**FIRE SERVICE LINE
 to serve
 2054 CUSTER
 LOT 1 BLK 4
 SOUTHWEST INDUSTRIAL ADD.
 CITY OF WICHITA, KANSAS**

**Gary Janzen, P.E. City Engineer
 Project Number
 1959 PPW (607853)**

AS BUILT PLANS
 Contractor: McCullough Excavation
 Inspector: Dakota Zimmerman
 Ruggles & Bohm
 PDF Made By: DGZ 03/08/2016

AS BUILT PLANS
 Contractor: McCullough Excavation
 Inspector: Dakota Zimmerman
 GARVER
 PDF Made By: DGZ 04/06/2018

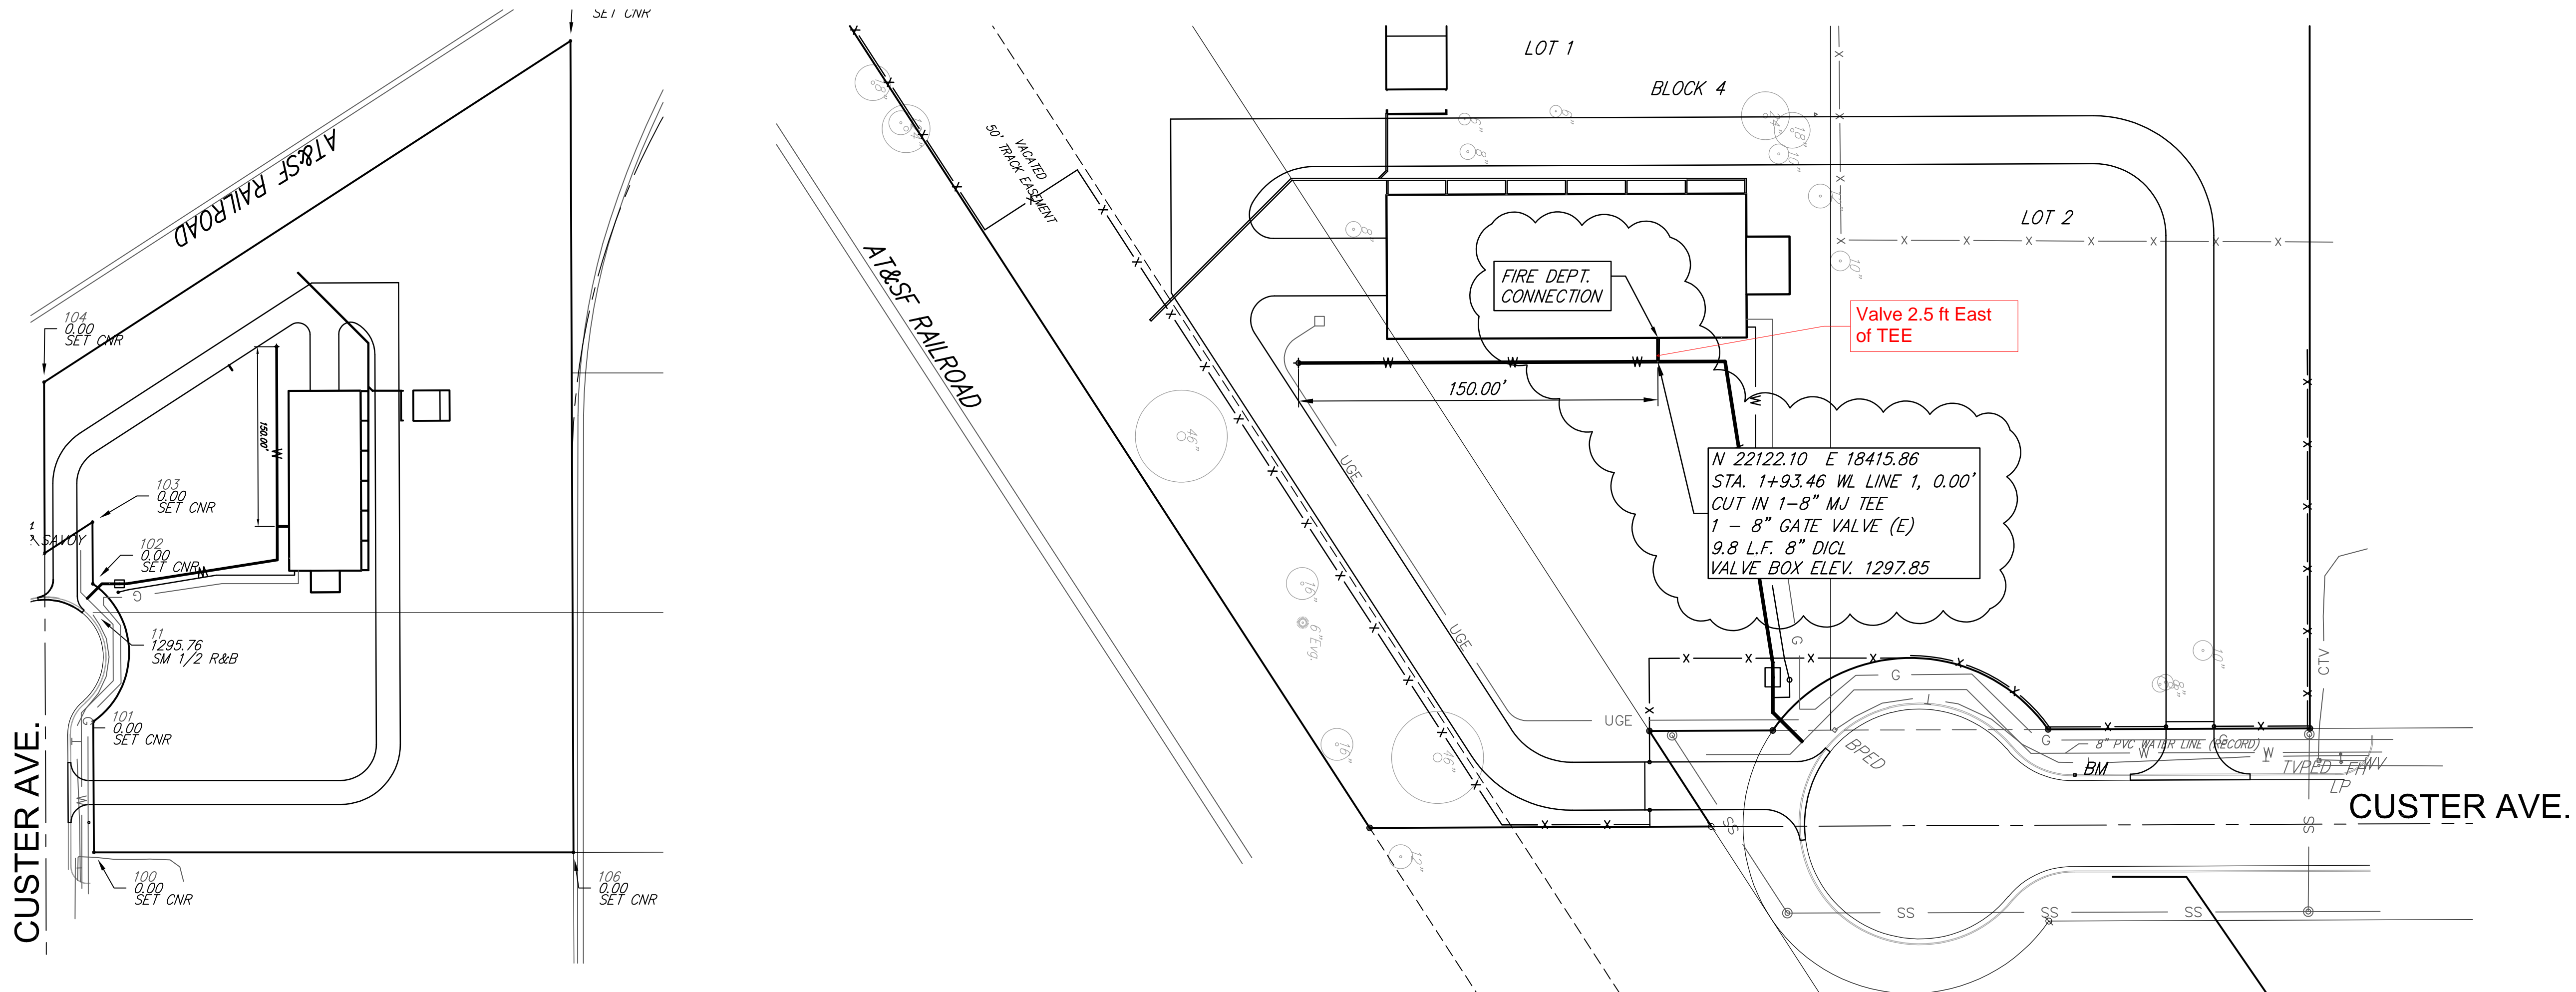
Building owner was denied
 Occupancy Permit due to no
 FDC connection. Sheet 4R
 added this connection and we
 inspected the install.
 -Dakota Zimmerman
 Garver 04/06/2018

Sheet 4R added for
 FDC
